To: **Planning Commission**
From: **Melissa Sonnek, City Planner**
Date: **August 18, 2020**

Conditional Use Permit, Site Plan, Rezoning, and Plat for 1571 Robert St.

Site Access – Robert Street

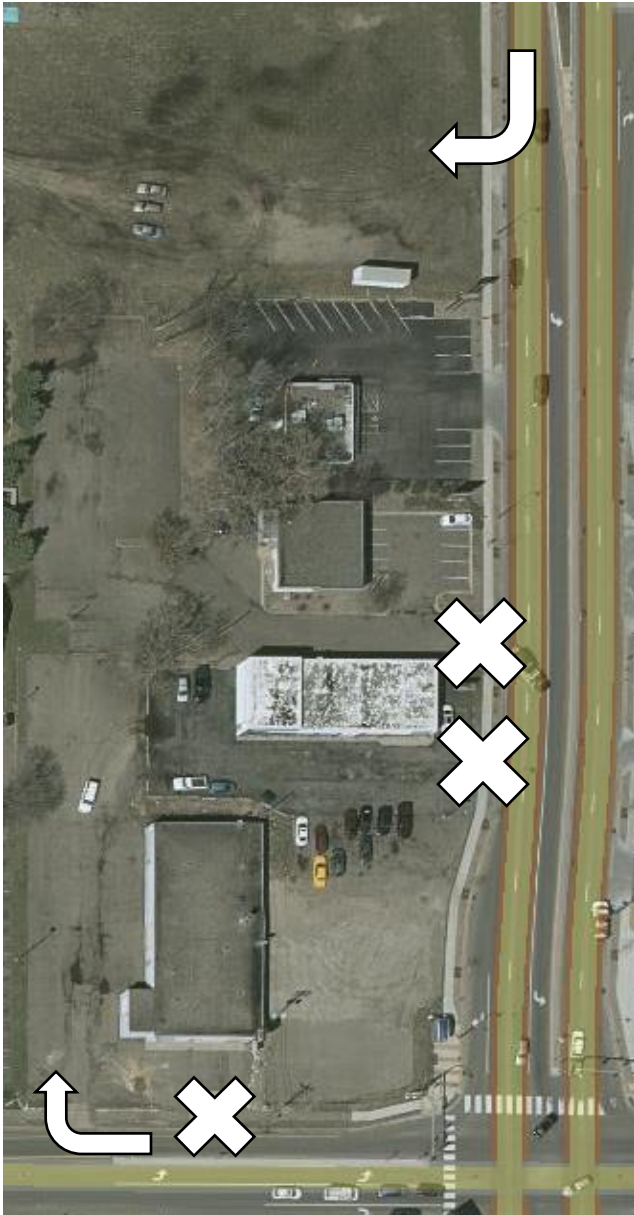
The site as it exists today, has several right in and right out curb cuts onto Robert Street. As with many state and county roads, when a site redevelops, multiple accesses are eliminated and one access point is allowed to remain. Since Granny Donuts is not included in the redevelopment proposal, their existing access will remain unchanged. However, the two curb cuts on the southern leg, will be removed and the northern most access (Blockbuster entrance) will remain.

Site Access – Livingston Avenue

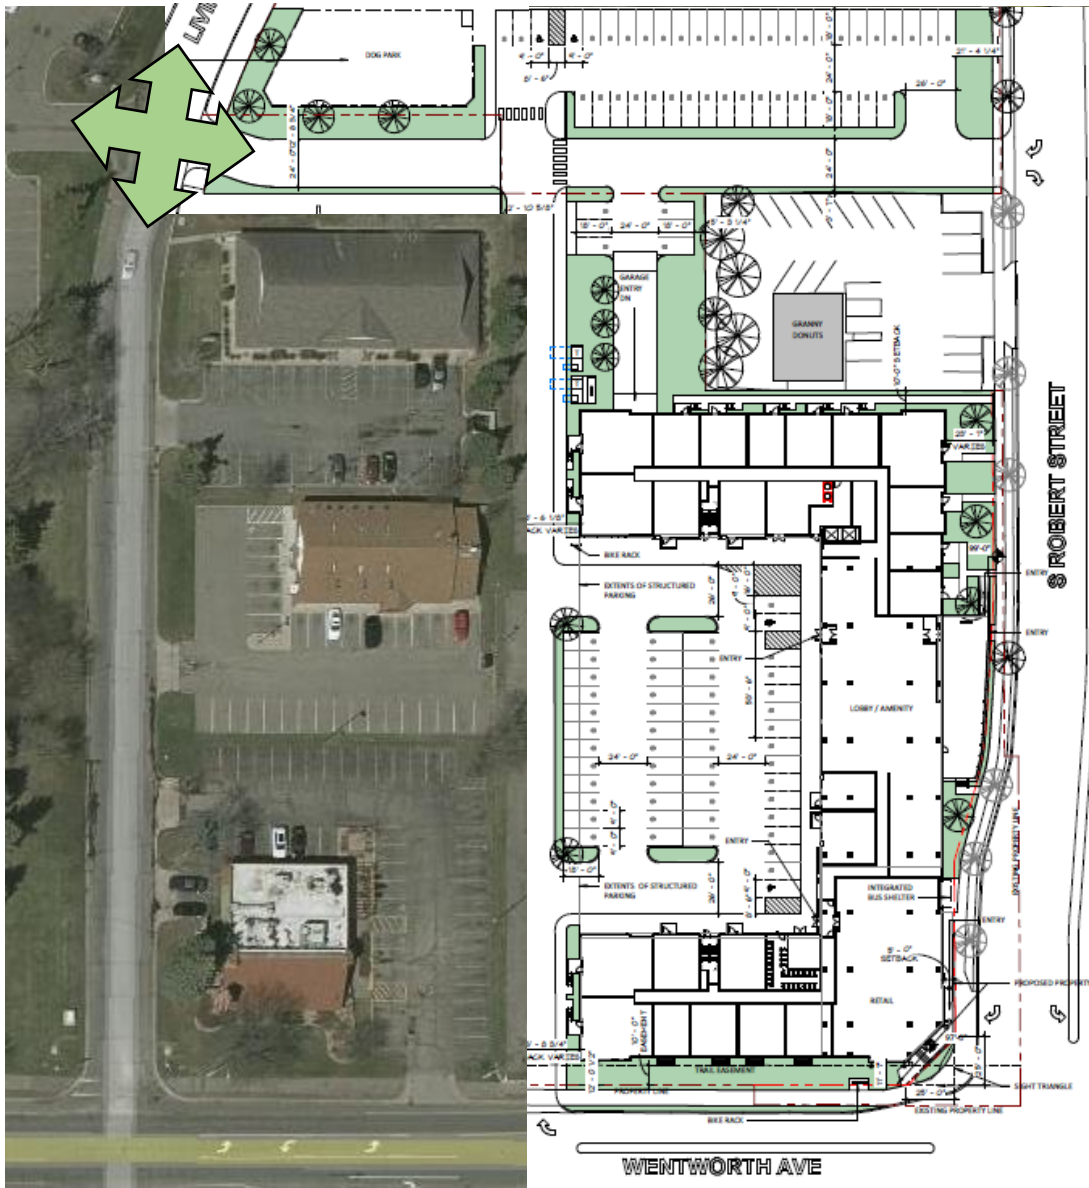
The site will have a full access (all turning movements) on and off of Livingston Avenue on the northwestern corner of the site. This access will line up nicely with the access to the multi-tenant office building to the west as shown in the image below.
